September 28, 2021

Product Change Notice - Bimini Quick Connect frame and actuator harness connectors

Fig.1

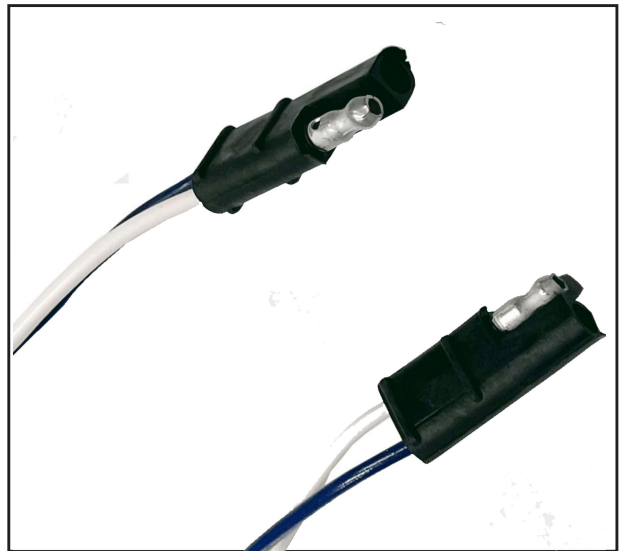
Please be advised, Lippert has changed the SureShade Power Bimini Quick Connect frame harness and actuator harness connectors from a spade connector (Fig. 1) to a black SAE plug (Fig. 2).

Current - spade connectors
